ST. TAMMANY PARISH

Addendum No.: 1

Bid#: 24-43-2

Project Name: Brewster Road Sewer Consolidation

SHEET NO.
10PP-07

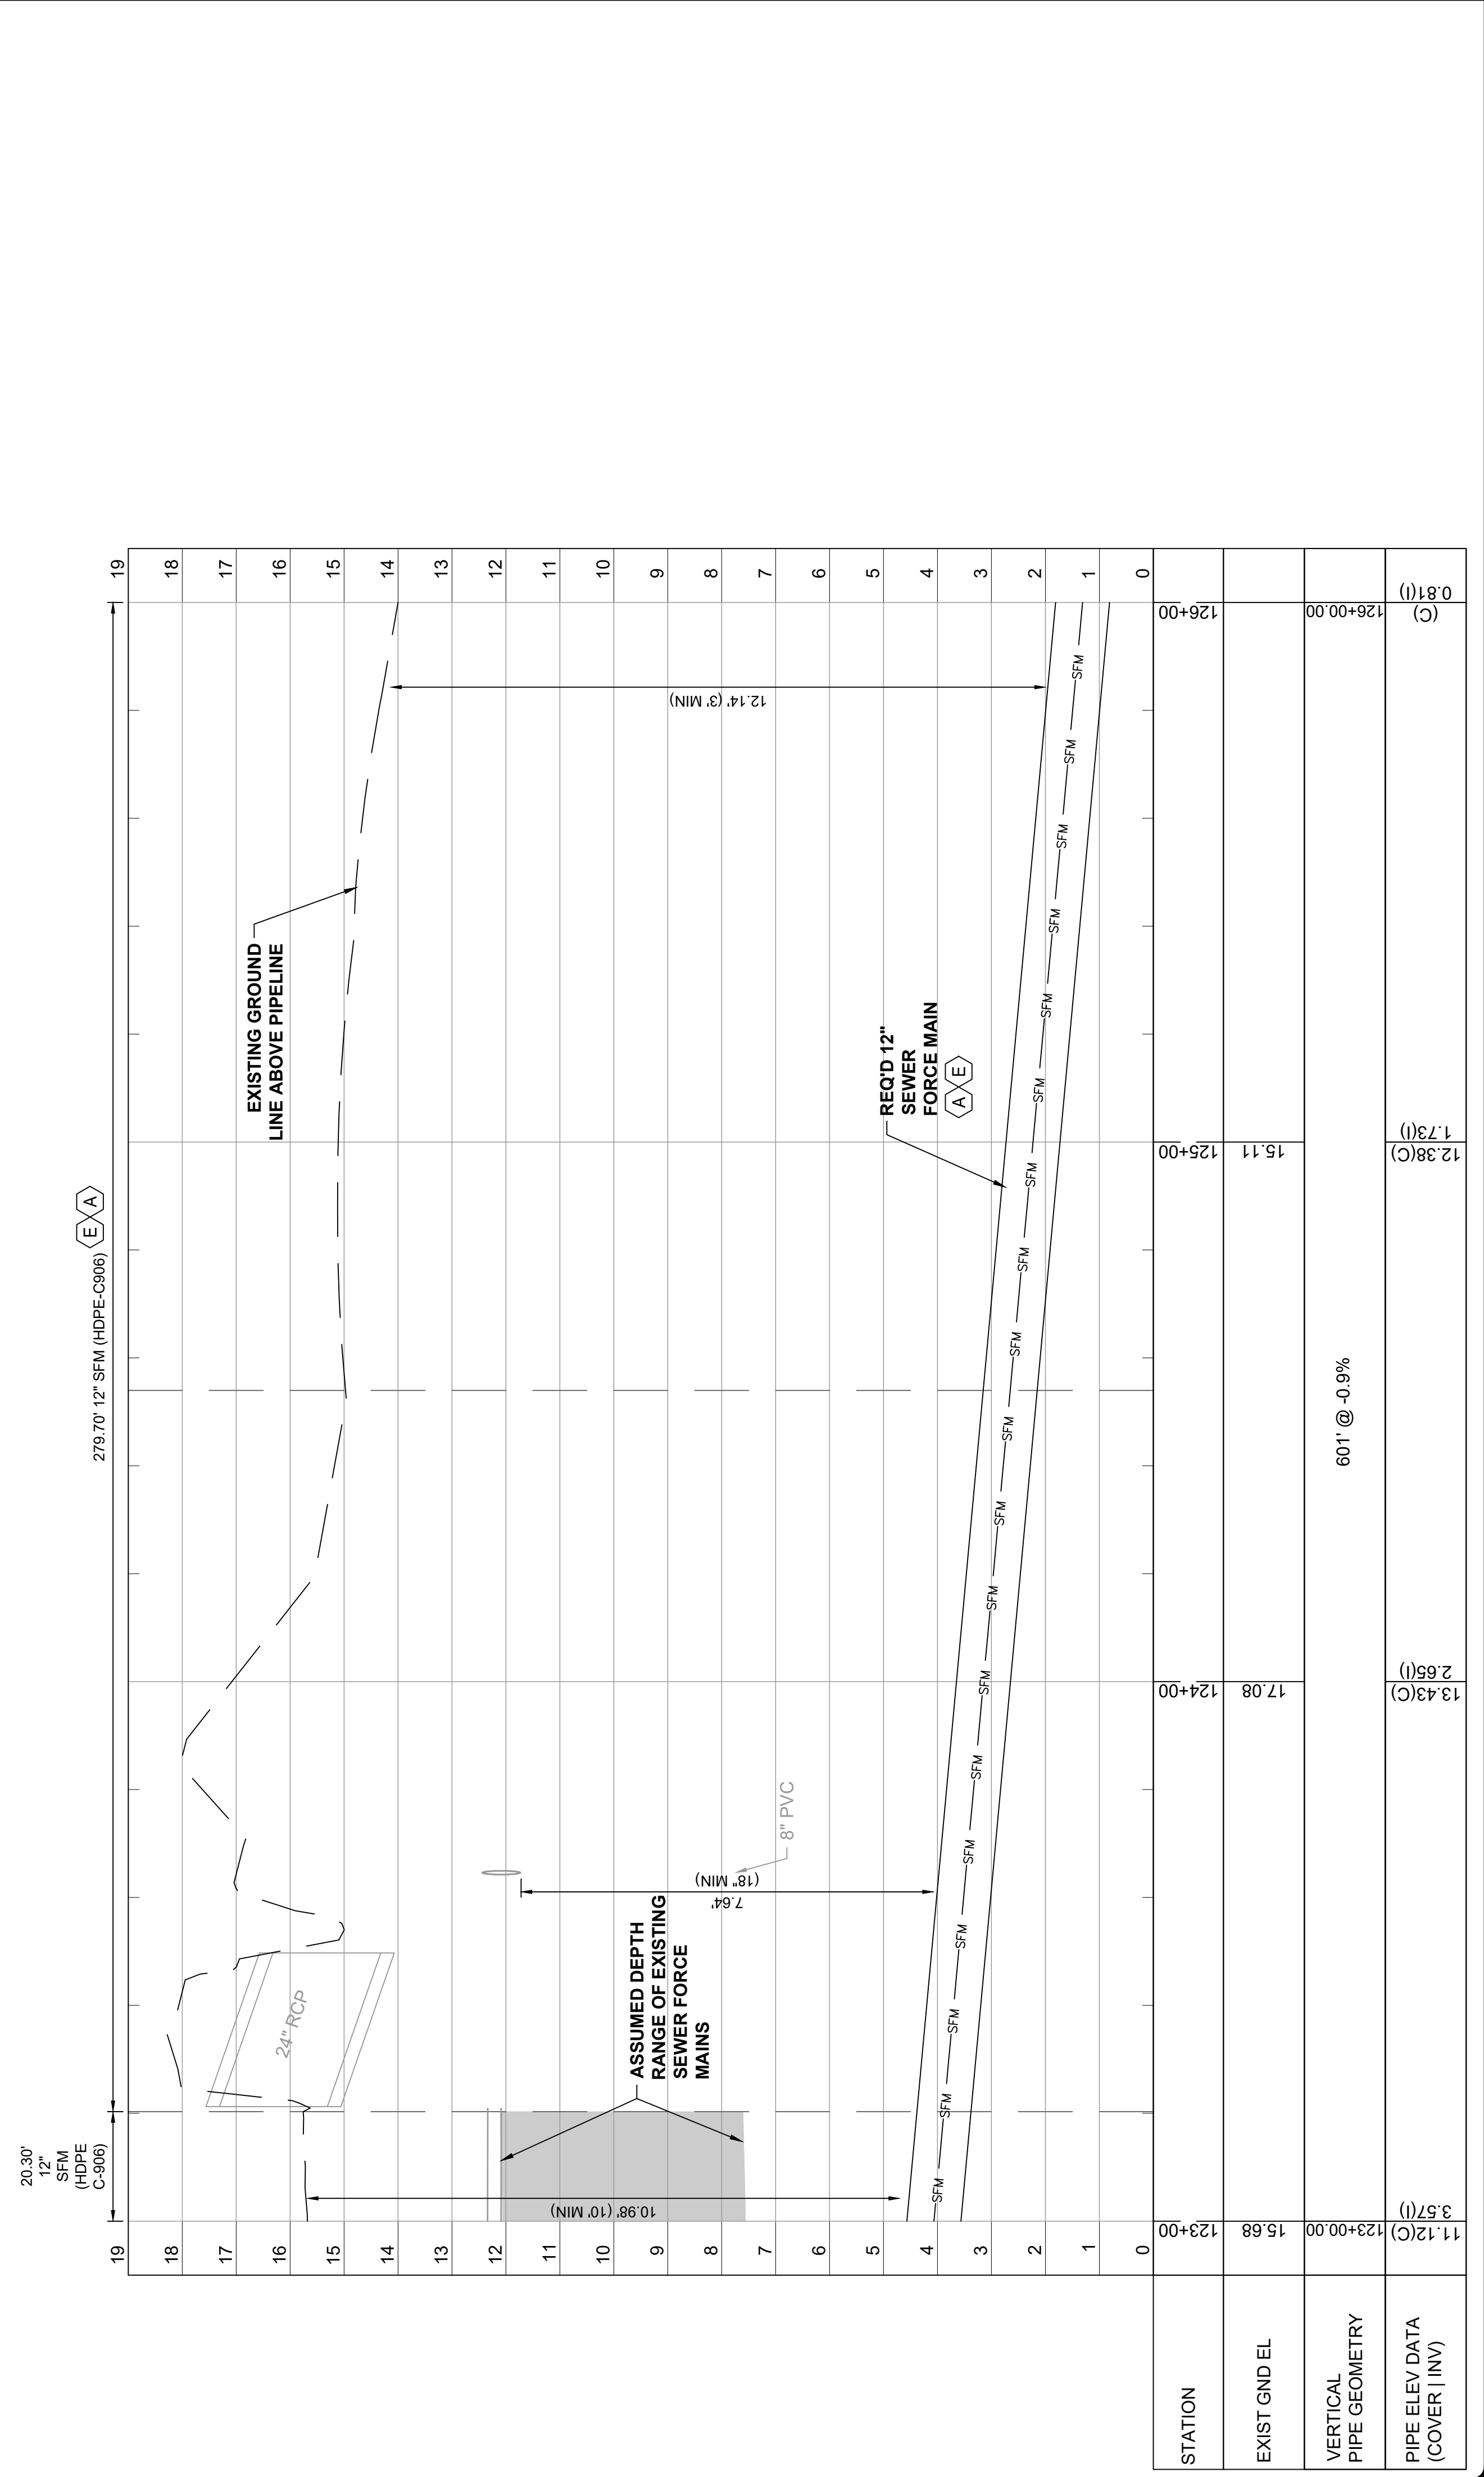
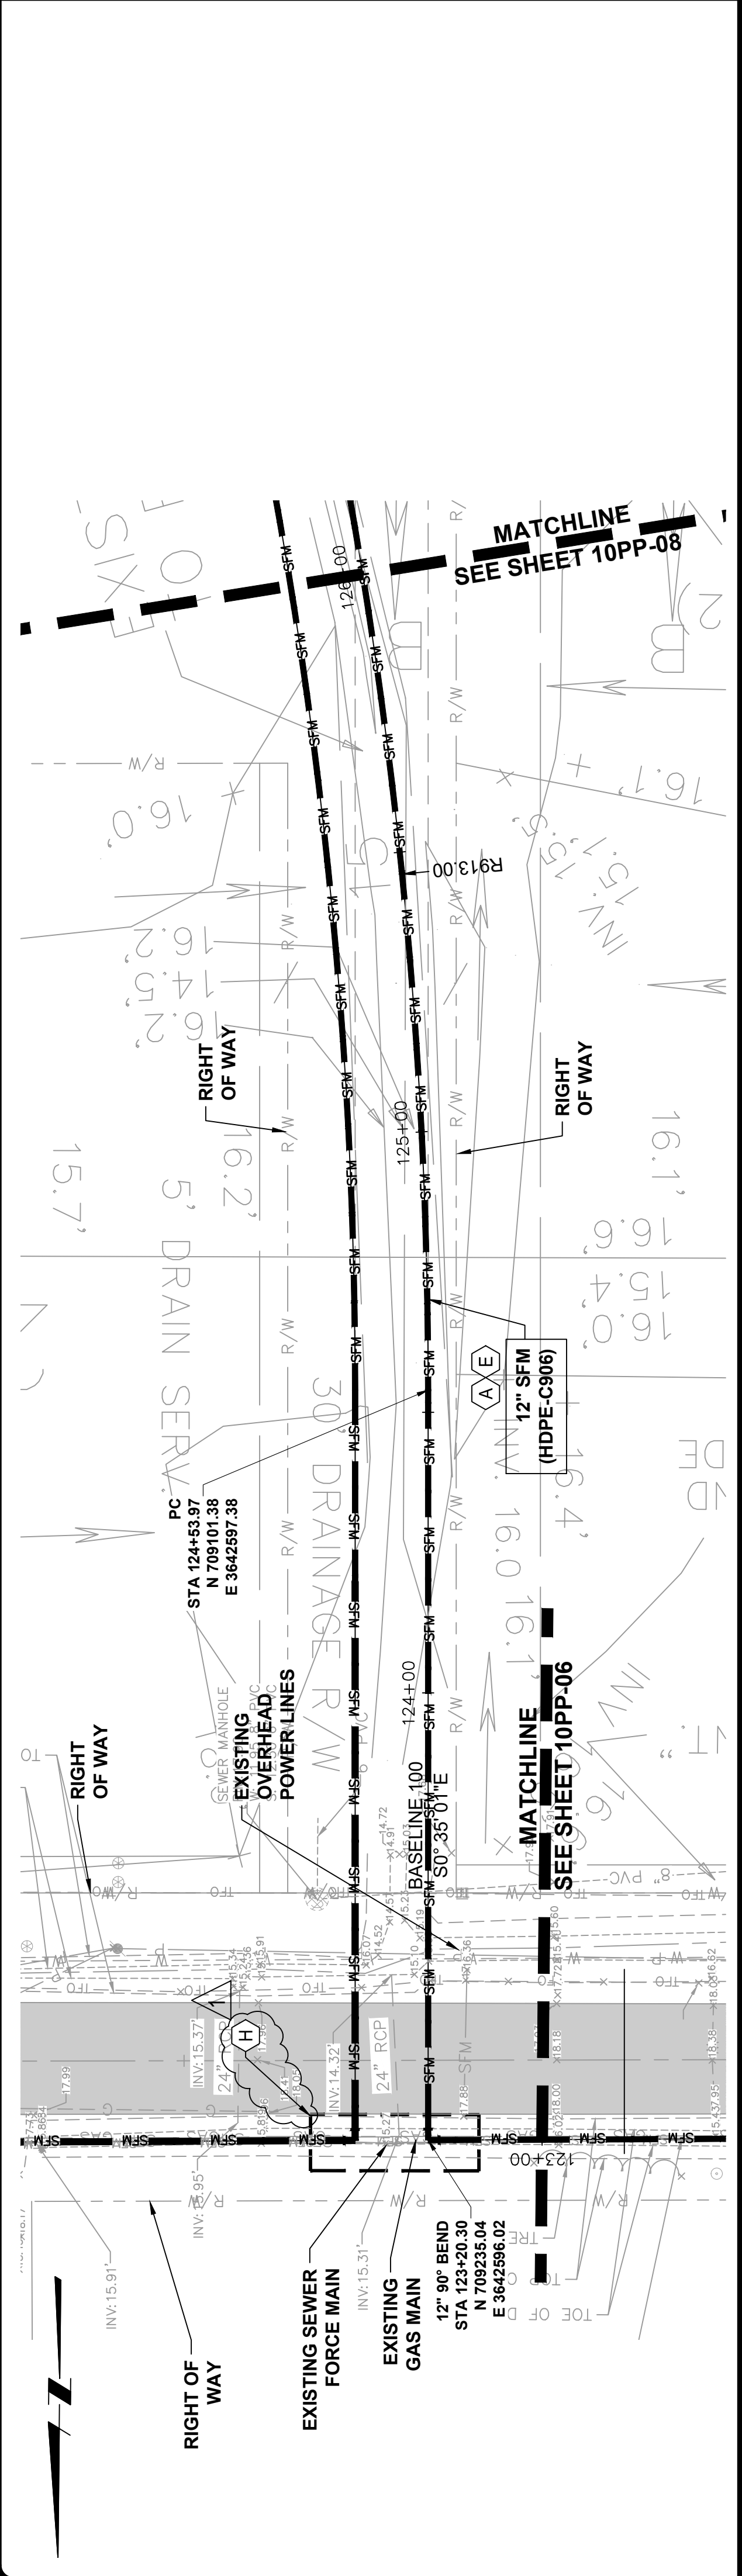
- c. DELETE Drawing 10PP-07 and REPLACE with the attached REVISED Drawing 10PP-07.
 - d. DELETE Drawing 10PP-09 and REPLACE with the attached REVISED Drawing 10PP-09.
